ADDENDUM 01, DELTA 01

DATE 01.30.2026

PROJECT: Santa Rosa Freestanding Emergency Room

ARCHITECT'S PROJECT NUMBER:
225014.00

1 ISOLATION EXAM - ENLARGED PLAN
SCALE: 1/2" = 1'-0"

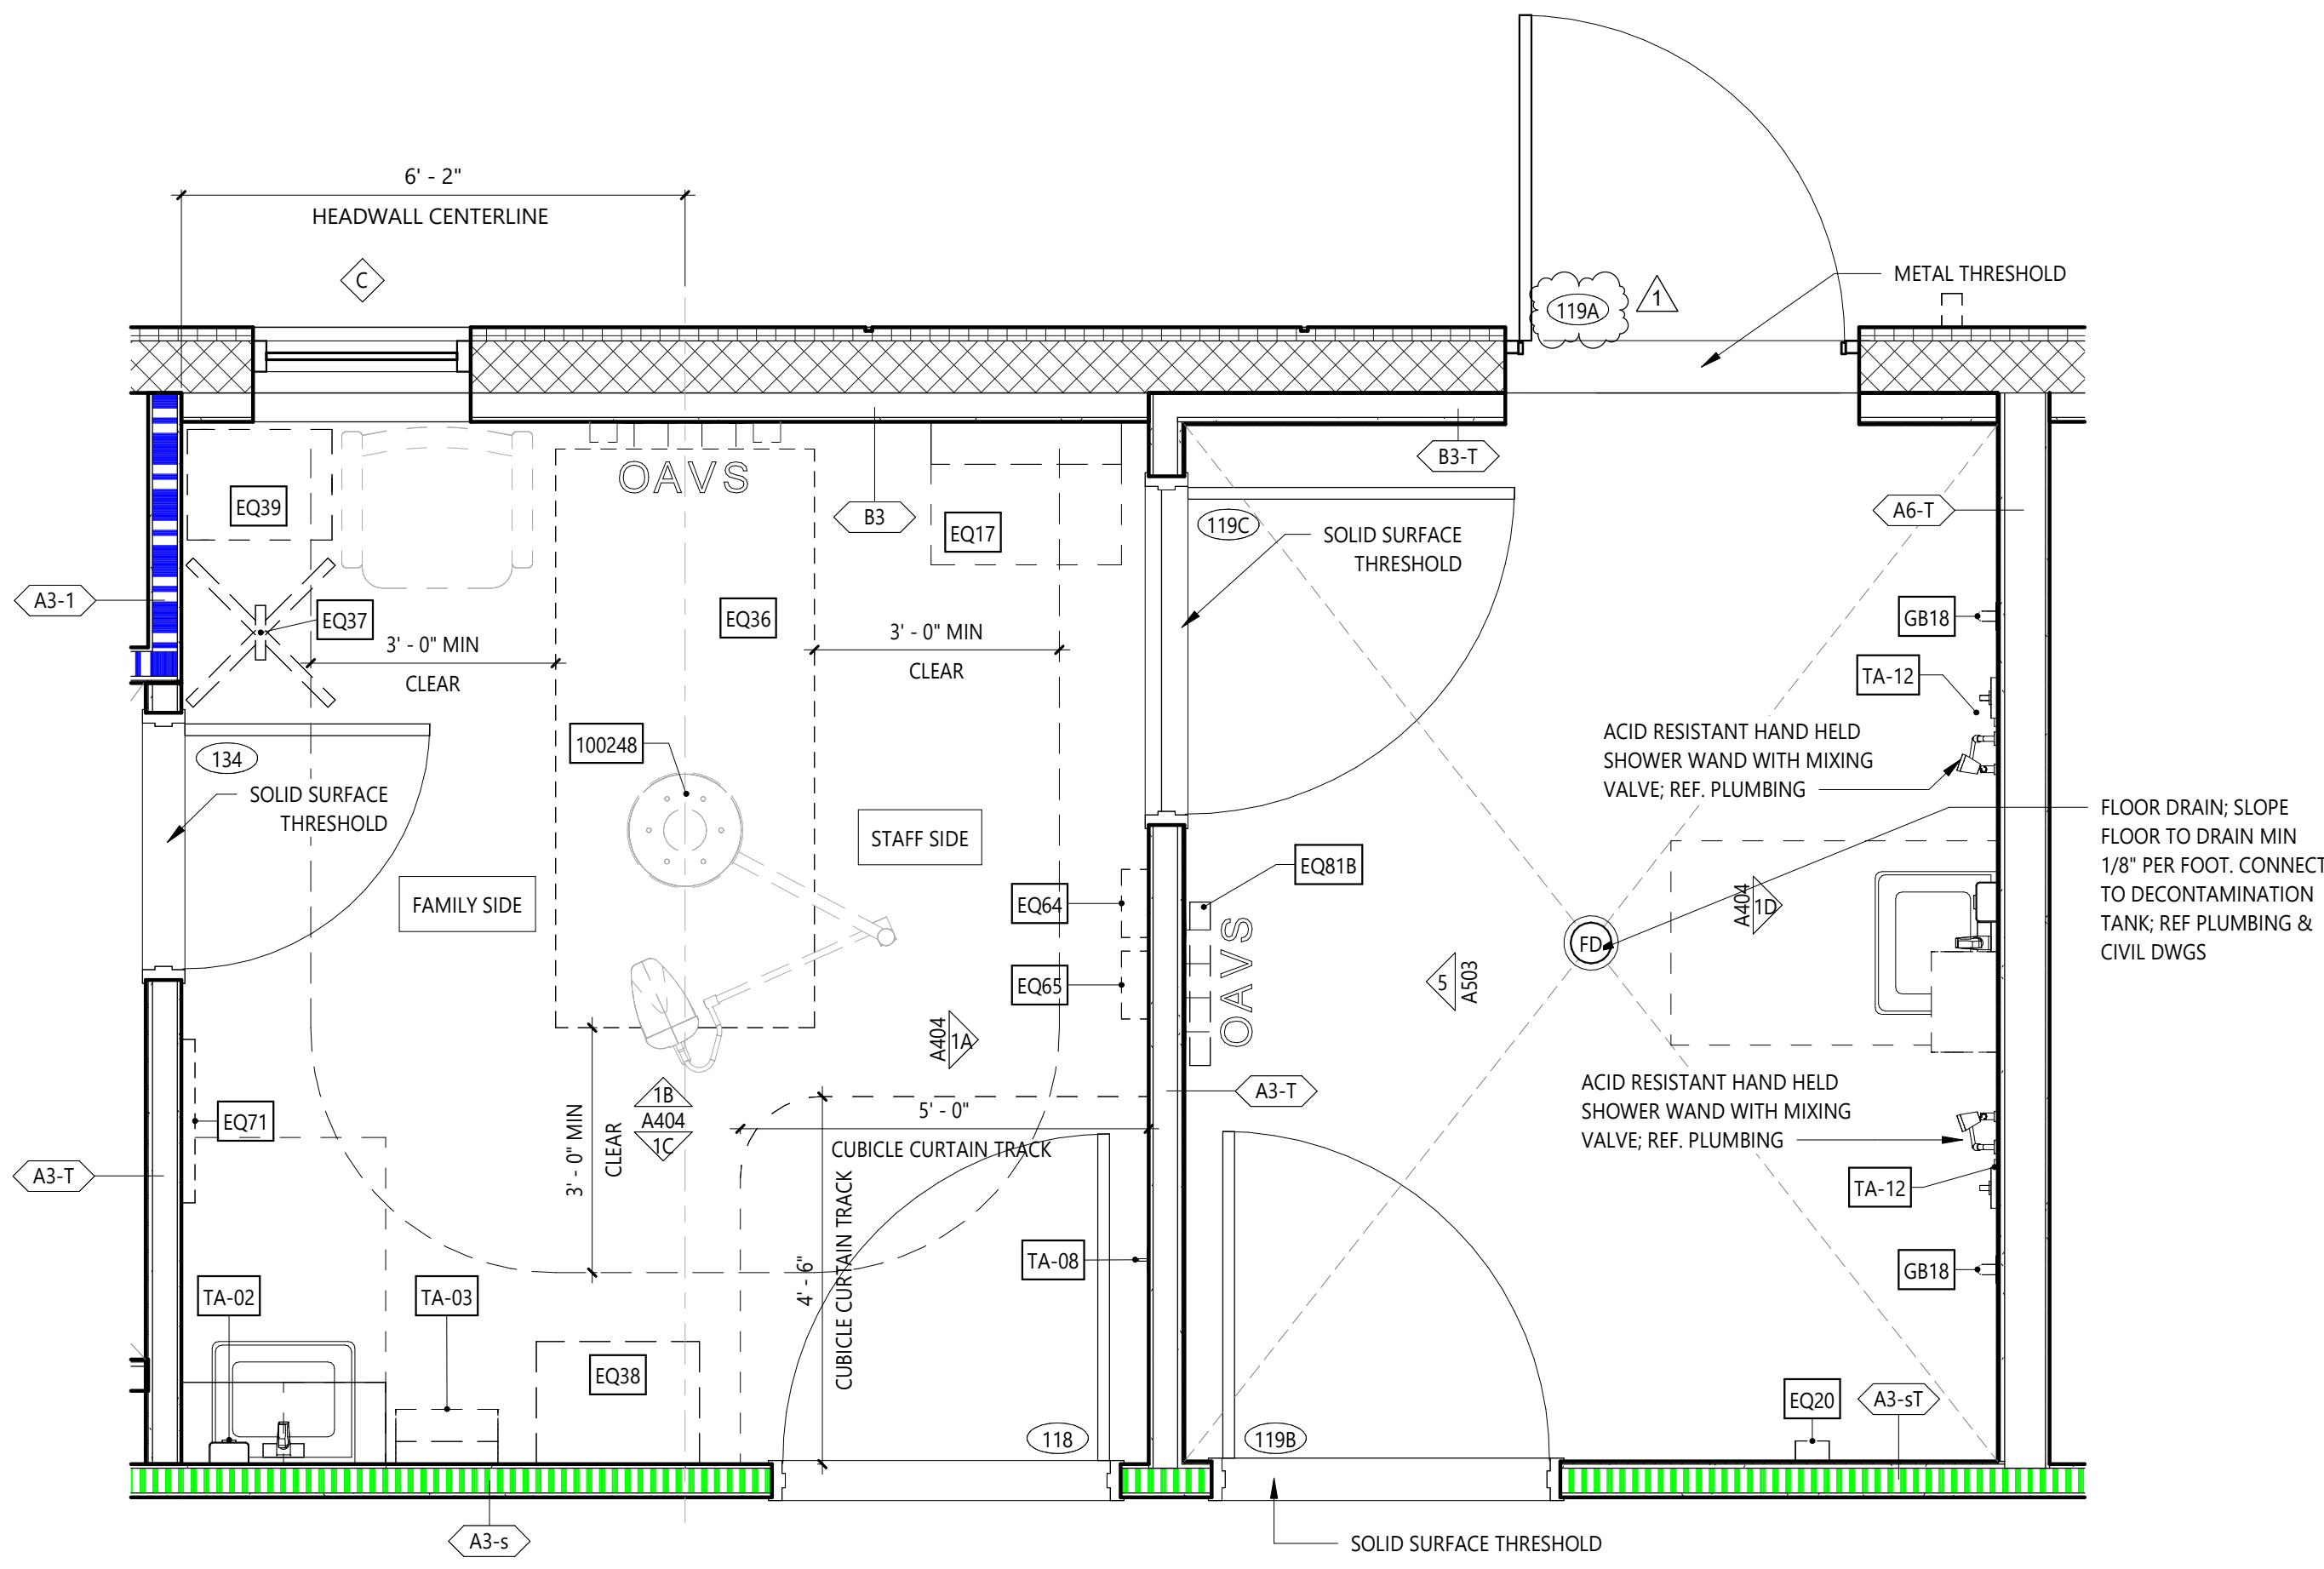
1. Reference Detail 1: "Isolation Exam – Enlarged Plan:"
 - a. Note added to indicate the gross and net room areas of the enlarged isolation exam per AHCA Stage II review comment. Graphic change only, no scope change.
 - b. Added door tag for Door 119A for additional clarification. Graphic change only, no scope of work change.
2. Reference Detail 2: "Isolation Exam – Reflected Ceiling Plan:"
 - a. Added "headwall centerline" to the centerline dimension for additional clarification. Graphic change only, no scope of work change.

P401

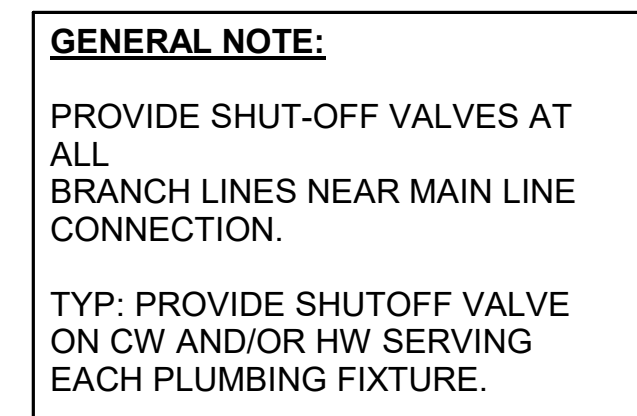
1. Updated risers to match floor plan changes on P101.

ELEC STUDY -
BREAKER CURVES

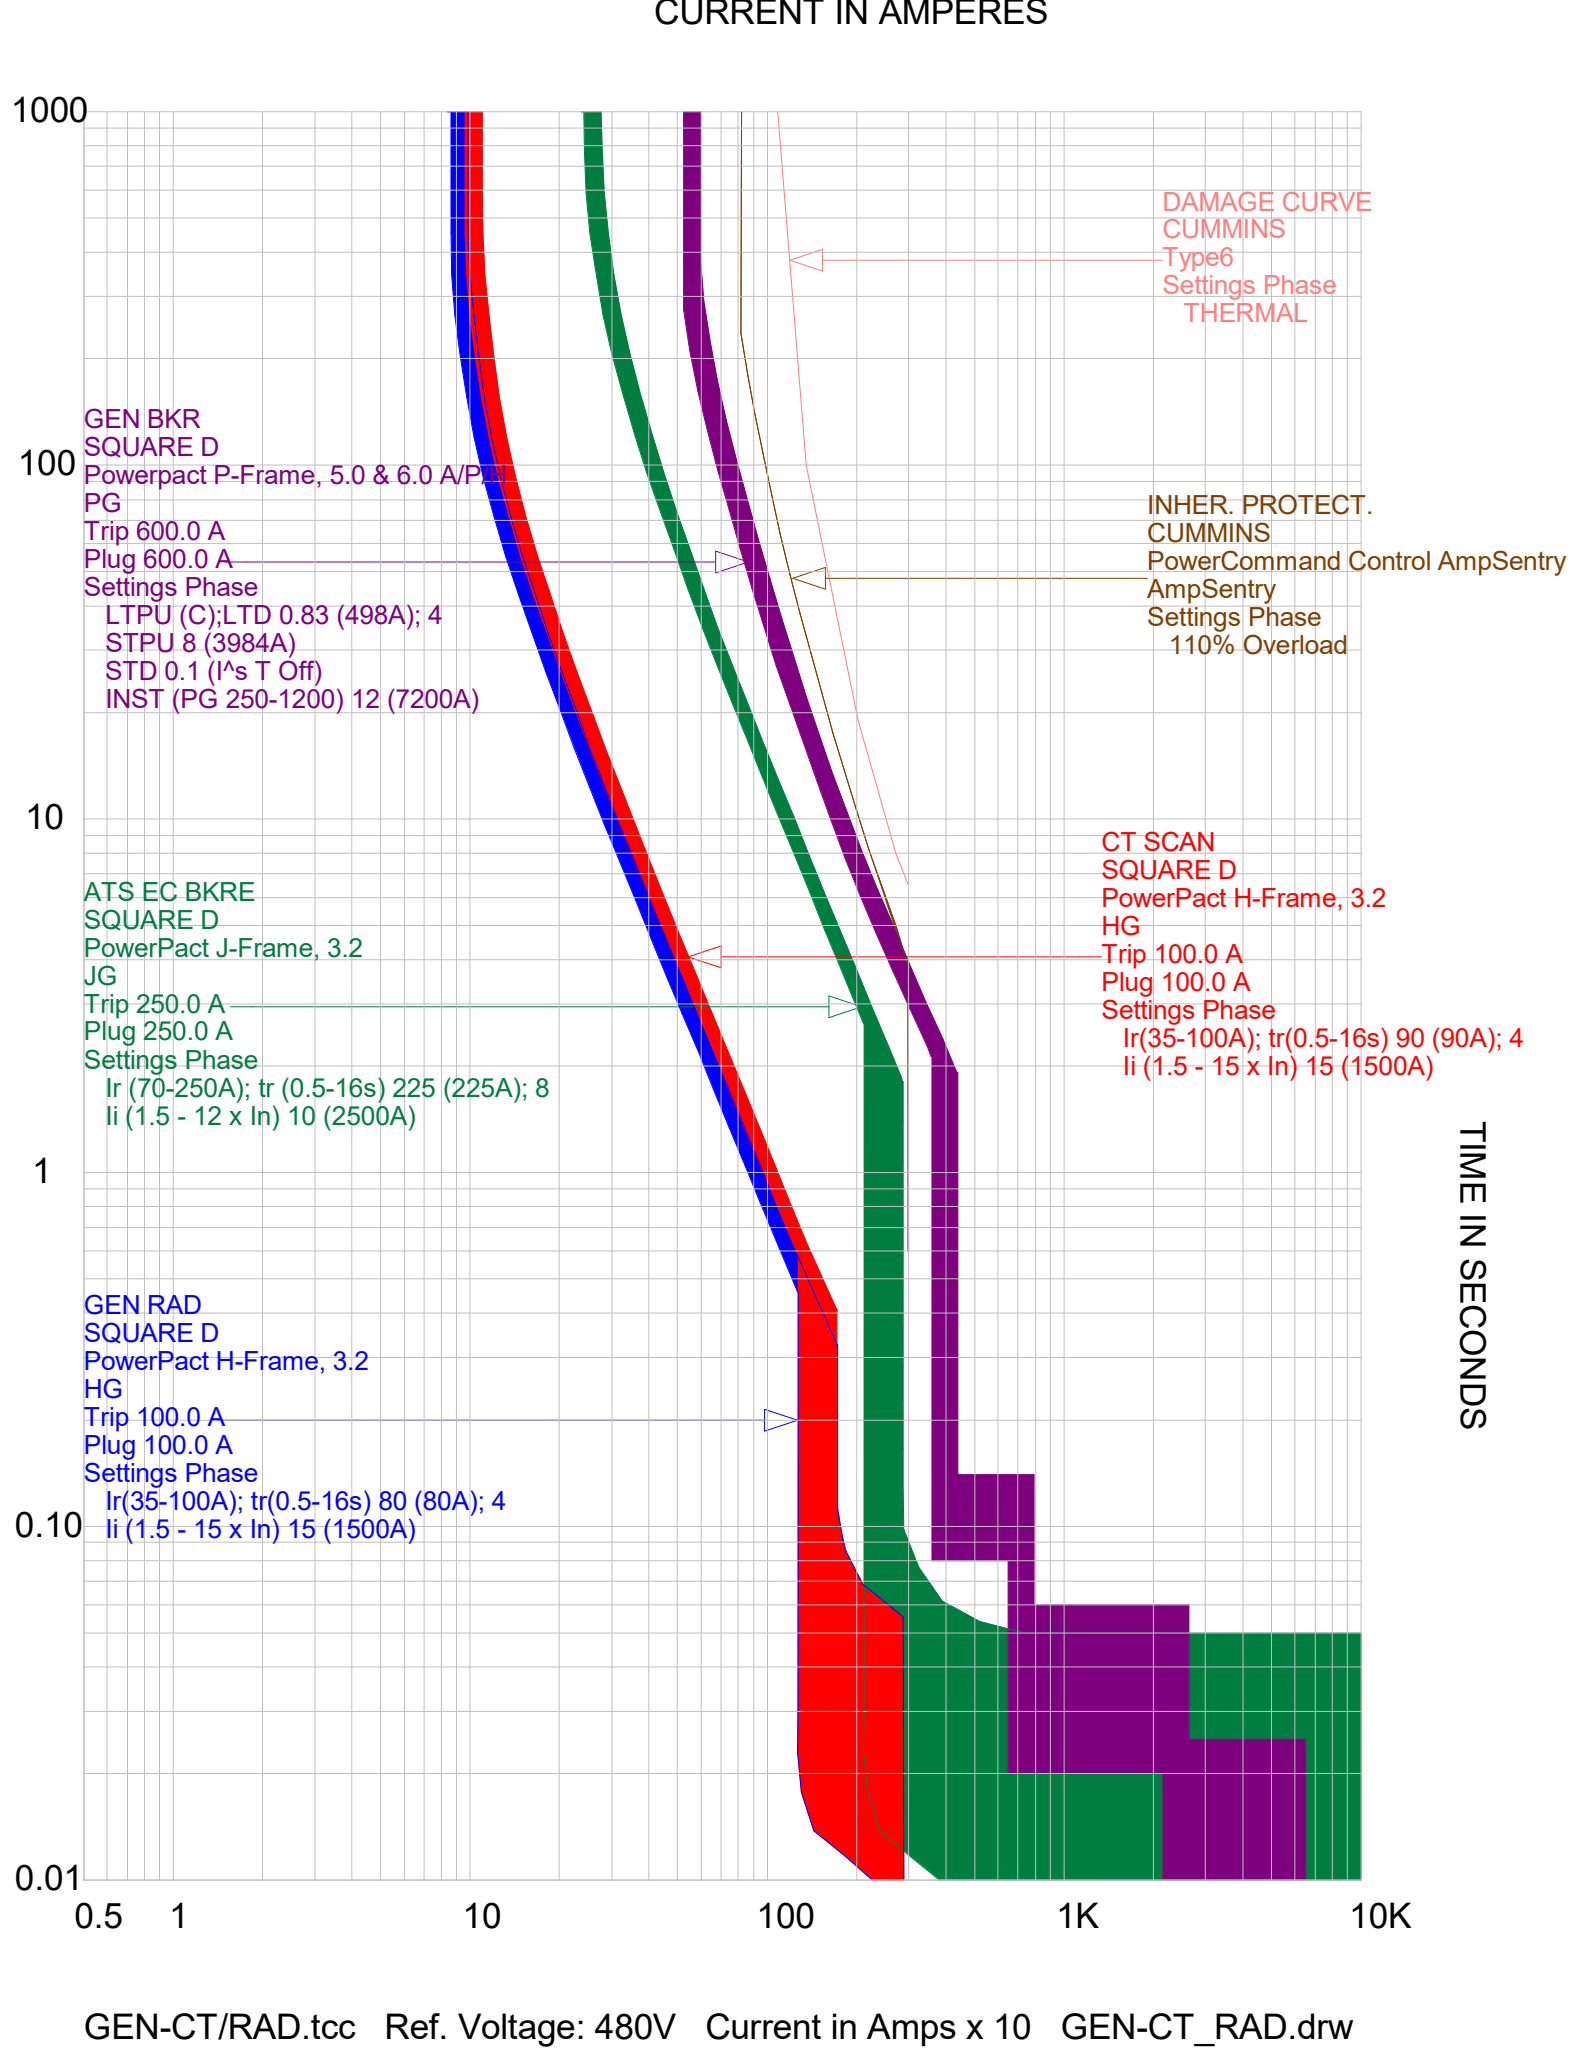
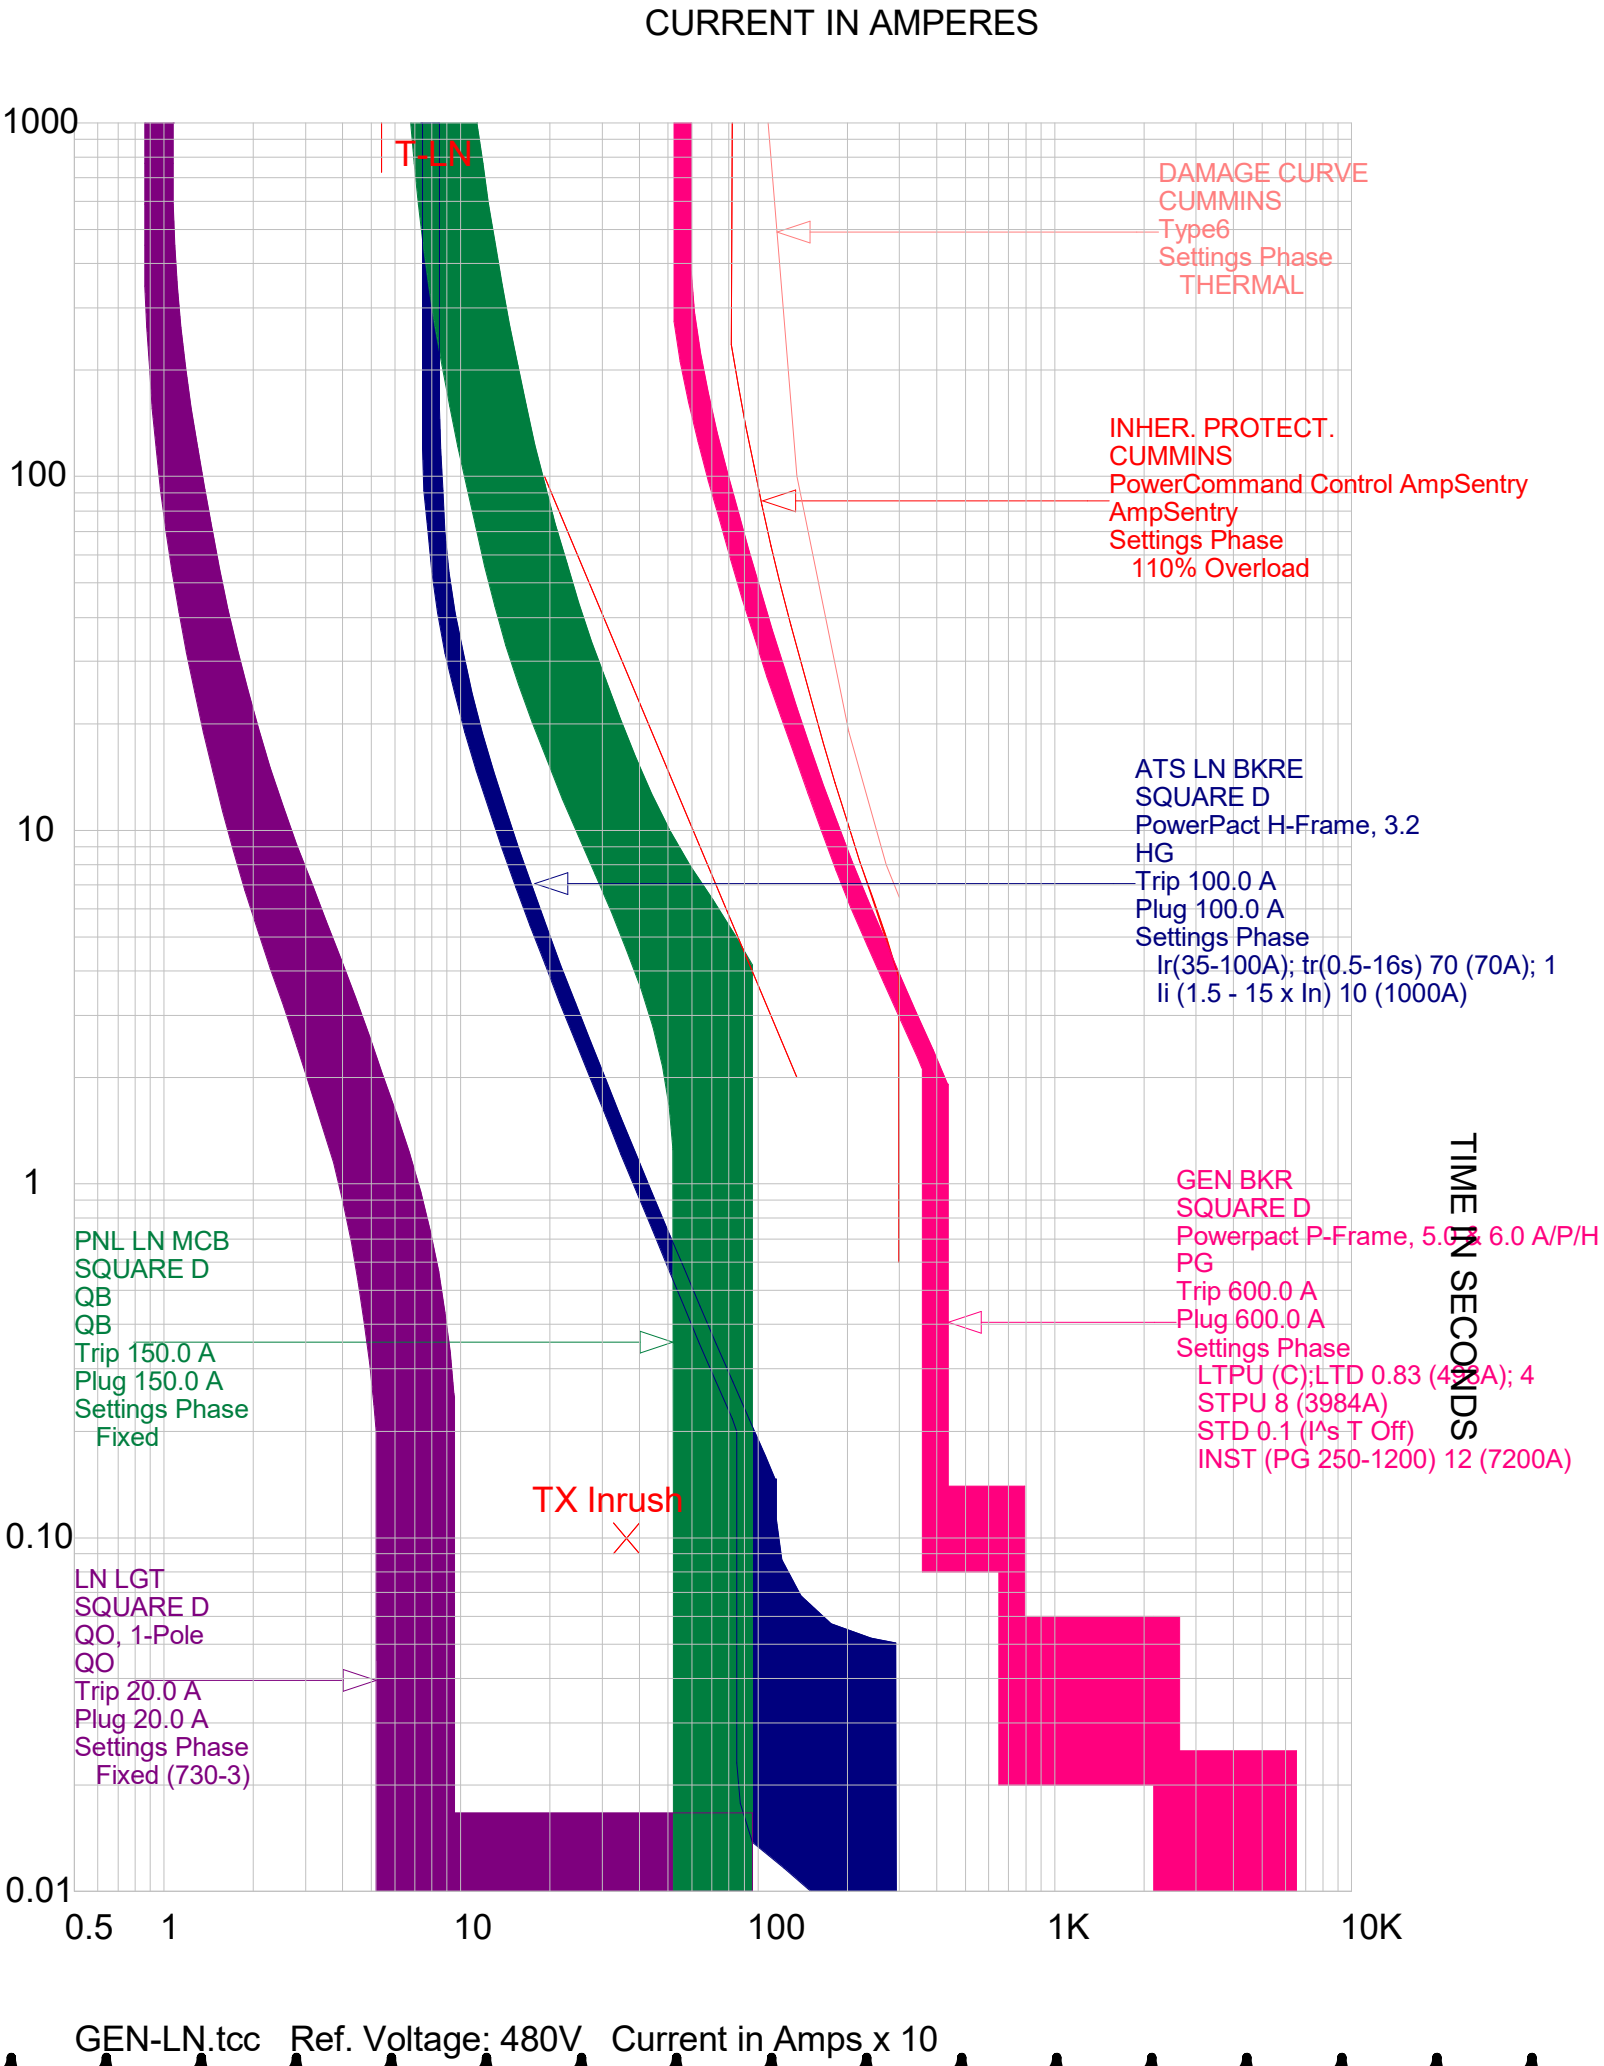
1. Revised the breaker curves to comply with AHCA comments.
